AMENDMENTS and REVISIONS
to the
Draft EIS

The Draft EIS was issued on November 21, 2003. As part of ongoing analyses and in response to comments received during the Draft EIS comment period and from ongoing agency discussions, a number of amendments and revisions have been made to the text. These revisions reflect minor additions and corrections to the text, updated data regarding existing traffic conditions, and supplemental analysis of water quality (phosphorous) impacts and mitigation measures.

WRITTEN COMMENTS on the DRAFT EIS RECEIVED FROM AGENCIES, TRIBES, ORGANIZATIONS and INDIVIDUALS and RESPONSES TO THOSE COMMENTS

Figure 3.15-2

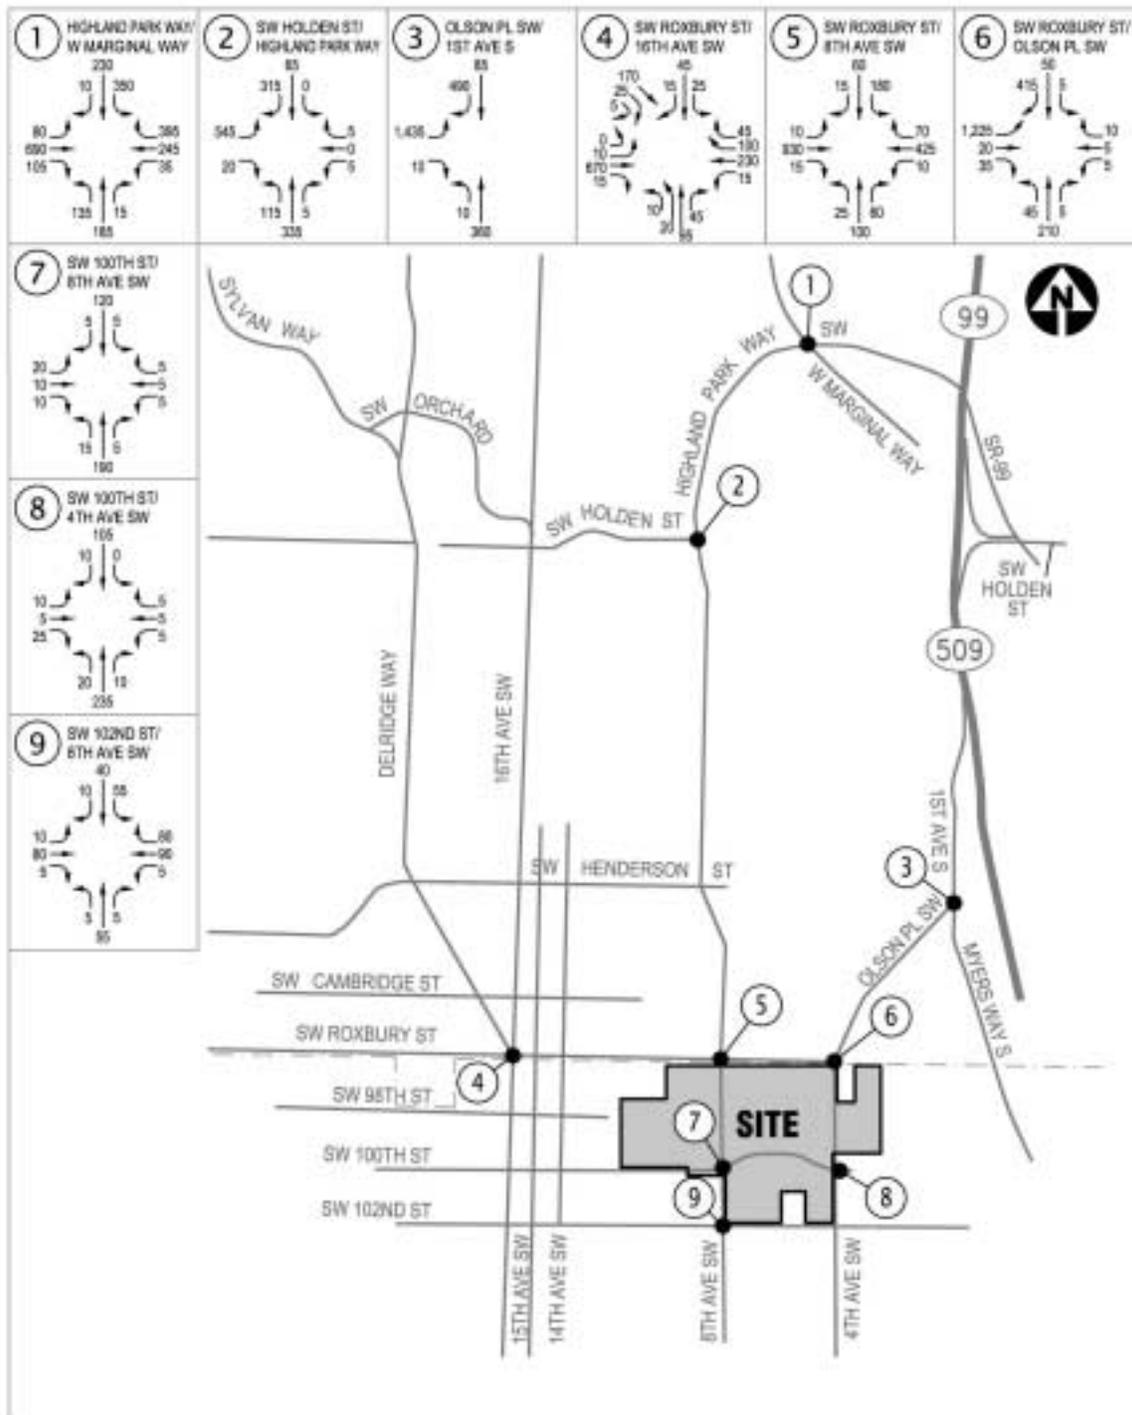
Vehicle volume counts that were collected in 2001 and shown in the Draft EIS have been updated. The vehicle volume counts have been increased by a 1.0-percent annual growth rate to estimate 2004 existing traffic volumes. **Figures 3.15-2** and **3.15-3** have been revised to show these volumes. In addition, **Table 3.15-1** has been revised to reflect the findings related to these updated volumes.

Figure 3.15a

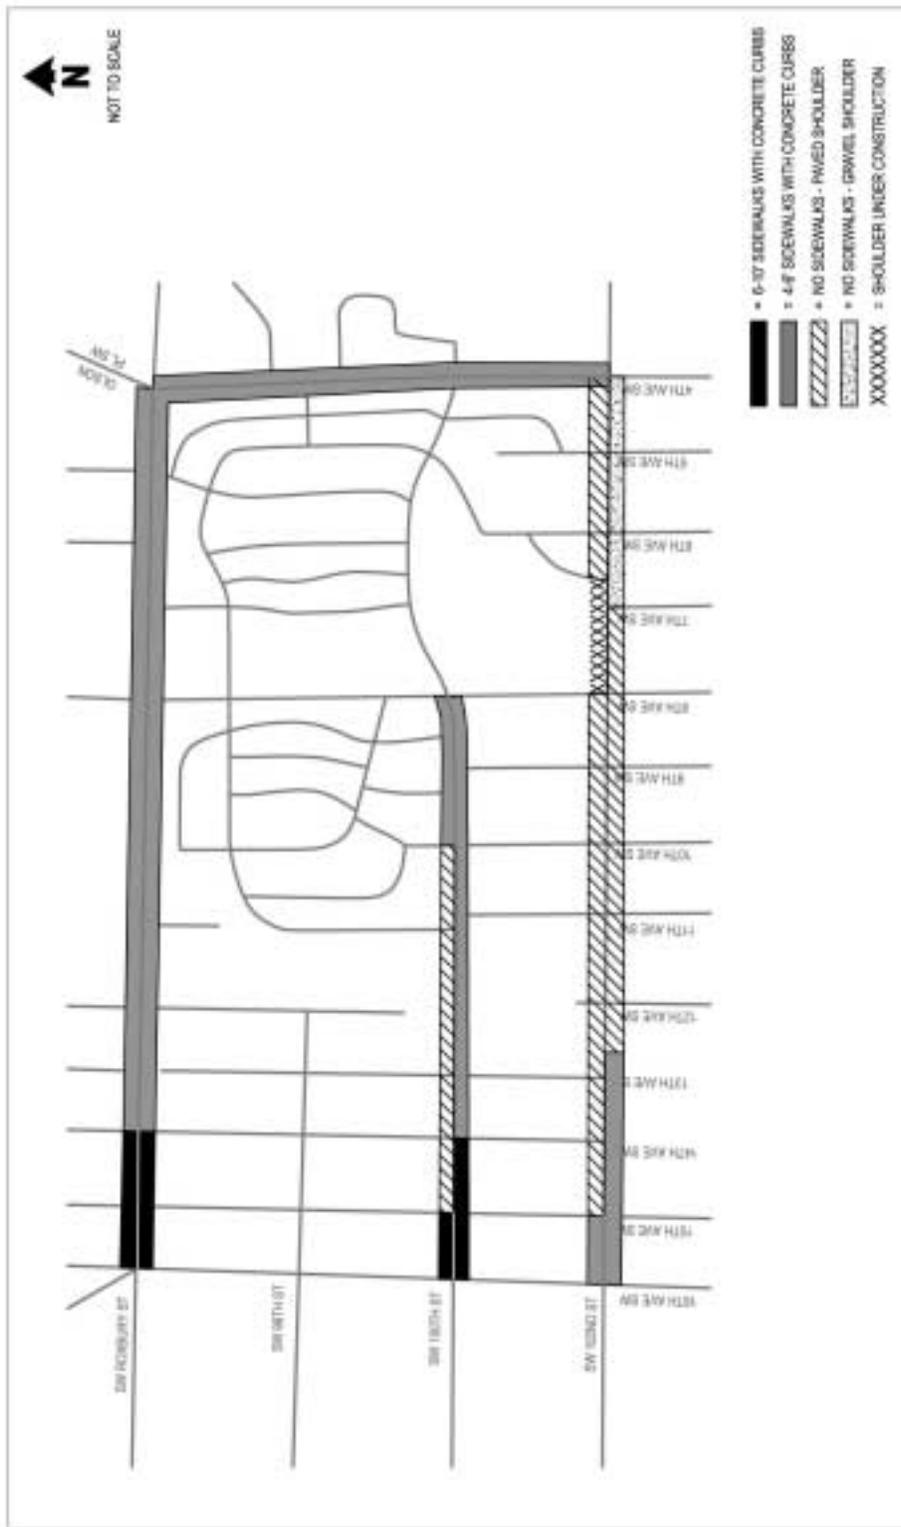
Figure 3.15a has been added to the Draft EIS following page 3-128. It provides an inventory of pedestrian facilities around and near the project sight. While sidewalks are provided along Roxbury and 4th Avenue SW, portions of SW 102nd Street and SW 100th Street do not provide sidewalks. These routes provide a direct connection from the project site to the commercial district of White Center.
